Delegated Report

Listed Building Consent Application

Planning Application No: 20240686

Location: Custom House The Terrace Gravesend Kent

Lower Ground Floor Plan

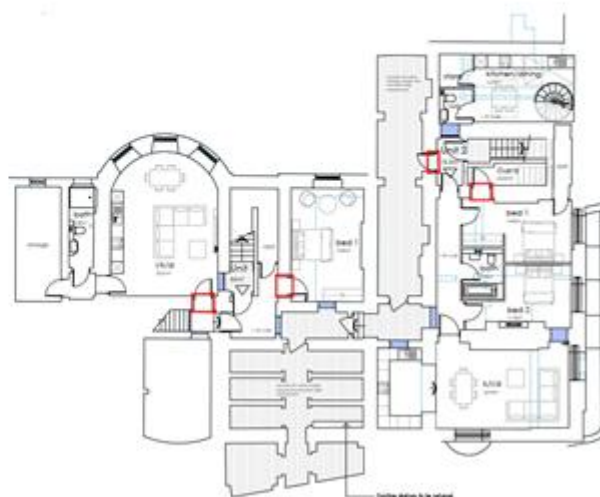
At basement level there are no changes proposed from what has been approved.

Upper Ground Floor Plan

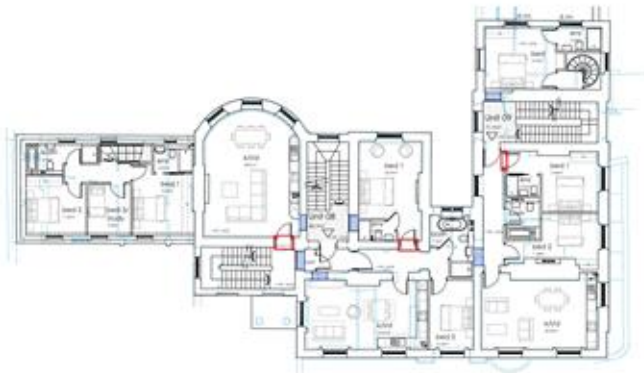
At upper ground floor level in unit 4 there would be new walls to create a cupboard in the hall. In unit 5 there would be new walls to create a cupboard in bedroom 2. In unit 6 there would be new walls to create a cupboard in the bedroom and a cupboard in the kitchen/living/dining room. In unit 7 there would be new walls to create two cupboards and a new wall already approved would be relocated slightly further north. Subject to detailing the material and method of attachment of the cupboards to ensure that they are a temporary and reversible feature it is considered that the proposed new walls would be acceptable.

First Floor Plan

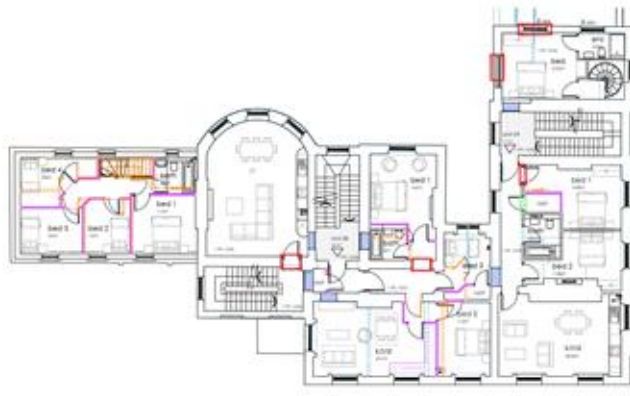
At first floor level in unit 4 which is part of the coach house the internal walls would all be slightly relocated however, this is acceptable as this is in the first floor extension which has been permitted to the coach house and so is not in historic fabric. In unit 8 there would be a new internal wall to create a cupboard in

bedroom 1 and walls that have already been permitted to form an en-suite would be slightly relocated to create a larger bathroom. In bedroom 3 there would be new walls to create a cupboard and in the combined kitchen/living/dining room there would be new walls to create a lobby area and relocation of an already approved wall slightly to the west. As the walls have already been approved in bedroom 1 and in the combined kitchen/living/dining room their slight relocation is considered acceptable and as above, subject to details of the cupboards it is considered they would be acceptable also.

Second Floor Plan

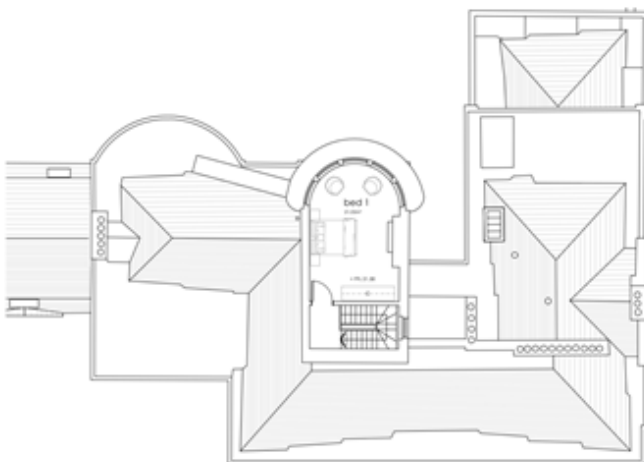
At second floor level in unit 10 there would be new walls to create a cupboard in the hall and to create a cupboard in the bathroom where a shower was shown in the approval (a bath is proposed). In unit 11 there would be new slightly re-located walls to create a slightly enlarged bedroom 2 to change this from a single to a double bedroom and formation of a new cupboard in place of an en-suite in bedroom 1. As the wall in unit 11 was already approved in bedroom 2 its slight relocation would cause no harm and the new cupboards would be acceptable as above subject to details.

Third Floor Plan

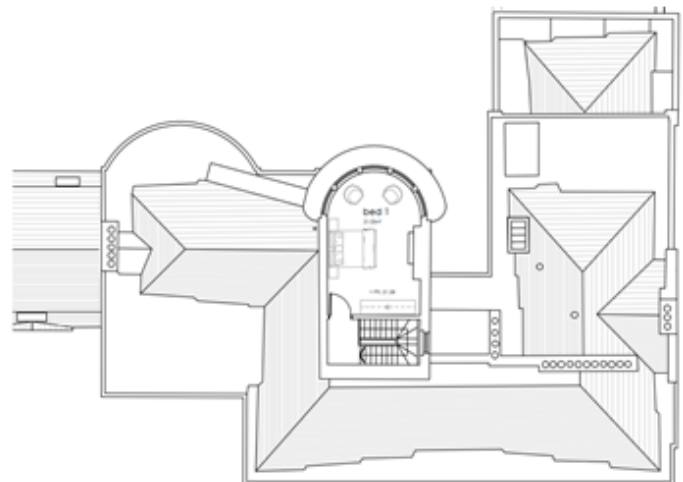
At third floor level there are no changes proposed compared to the approved scheme.

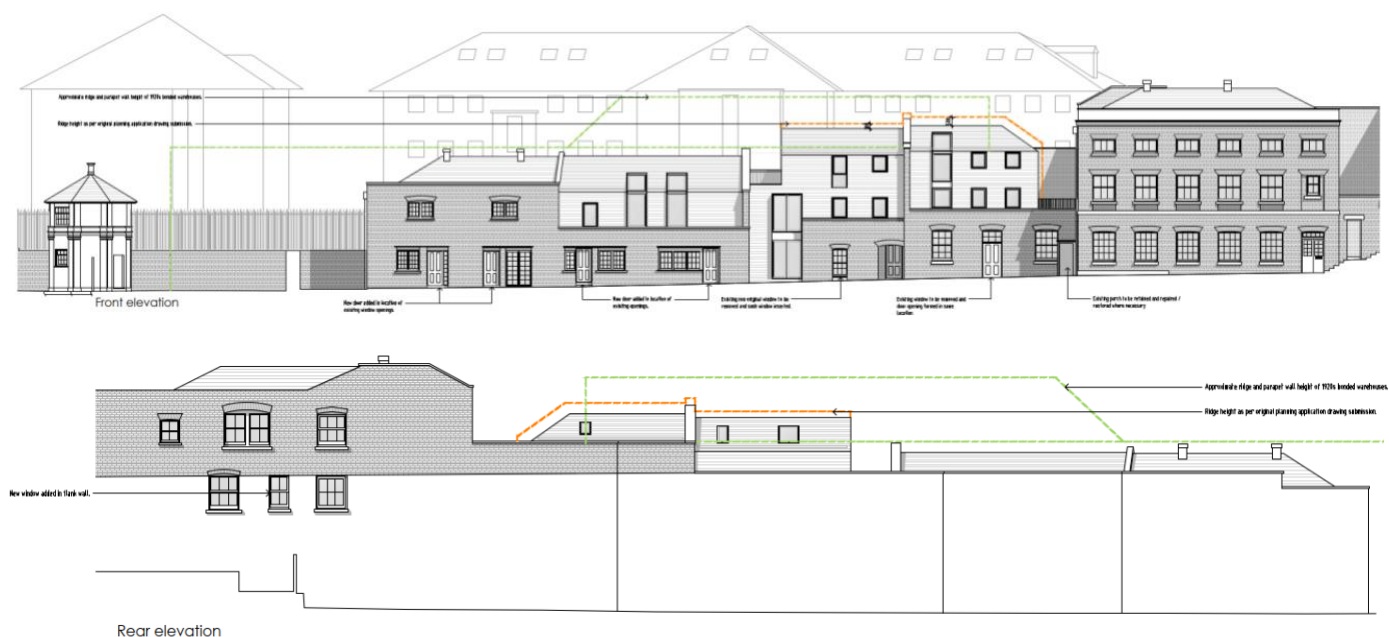
Compared to the original approval under Listed Building Consent ref. 20210758 there are further changes proposed in respect of internal alterations in terms of walls and cupboards. In unit 12 there would be the installation of cupboards in bedrooms 2 and 3 at upper ground floor level and a slight relocation of an already approved wall to enlarge bedroom 4 to change it from a single to a double bedroom. In unit 13 there would be slight relocation of two already approved walls to change the approved bathroom at first floor level into bedroom 5. In unit 14 there would be new walls at first floor level to form a cupboard in bedroom 1. In unit 15 there would be new walls for the installation of a cupboard in the bathroom at upper ground floor level and at first floor level there would be the relocation of the approved internal walls to change the approved layout of a double bedroom, dressing and en-suite to two single bedrooms and a cupboard. In units 16, 17 & 18 there would be the installation of walls to create cupboards in the landings at upper ground floor level. In unit no. 19 there would be the installation of walls to create a cupboard at lower ground floor level in place of the approved study. The re-location of walls and new cupboards are considered acceptable. Subject to conditions the proposals to the coach house are considered acceptable.

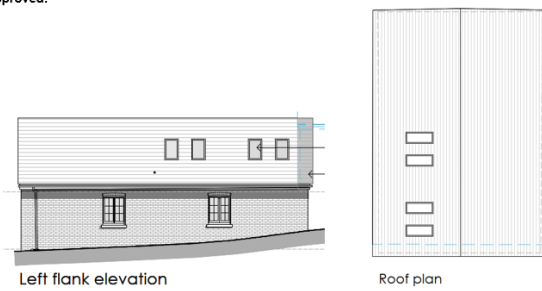
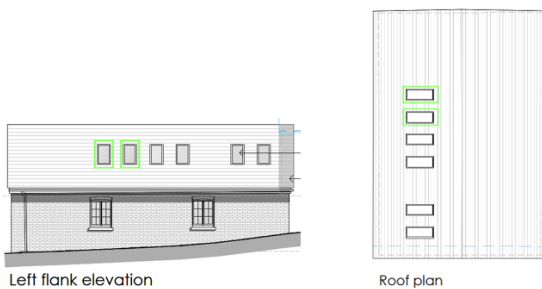
Workshop – The mid-20th century element attached to the rear would be demolished which is considered acceptable as it is not of any architectural or historic value and identified as neutral heritage significance in the Strategy. The workshop element to remain (which is of low heritage significance) would have new and altered window and door openings and a first floor put in. These are considered acceptable given the minor alterations, which will be an improvement in respect of the fenestration and given the low heritage significance of the building. The proposals to the workshop are therefore considered to respect this curtilage listed building, the setting of the main Grade II listed Custom House and Gazebo and other curtilage buildings on the site, the setting of the surrounding listed buildings and would protect the character and appearance of the Riverside Conservation Area. Compared to the original approval under Listed Building Consent ref. 20210758 there are changes proposed in respect of the rooflights and wall arrangement. Four rooflights were permitted under ref. 20210758 in the left flank roof slope and two additional rooflights are proposed to make six overall.

The two additional rooflights in the left flank roof slope of the Old Boathouse are considered acceptable and would be modest additions to the rooflights already approved under ref. 20240758. Within the workshop there would be alterations to the approved layout at first floor level. The first-floor level does not exist currently and would be formed in the building with the aid of rooflights. As the formation of the first floor is completely new, the re-ordering of the approved internal layout is considered acceptable. The increase in the amount of accommodation at first floor level is also acceptable as the two additional rooflights that are proposed in addition to the four already approved would be satisfactory in respect of character and appearance and the setting of the listed buildings on the site. Subject to details the proposals to the workshop are considered acceptable.
